Product Change Notification

Change Notification #: 110903 - 01
Change Title: Intel® Desktop Board DH67BL, Boxed and Bulk
PCN 110903-01, Product Material
Replace PWM CONTROLLER,
Reason for Revision: Add CPU Socket Cover Change
Date of Publication: August 10, 2011

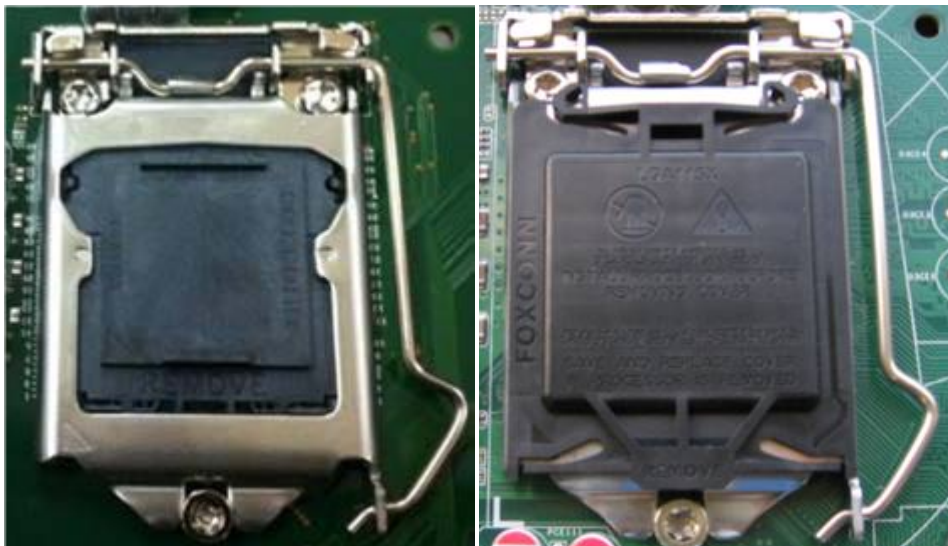
1. The Pulse Width Modulation controller CHIL 8104 upgraded from version E4 to E5 to enhance performance.
2. The CPU socket cover will be changed to the ILM version.

Current socket with PNP cover

New socket with ILM cover
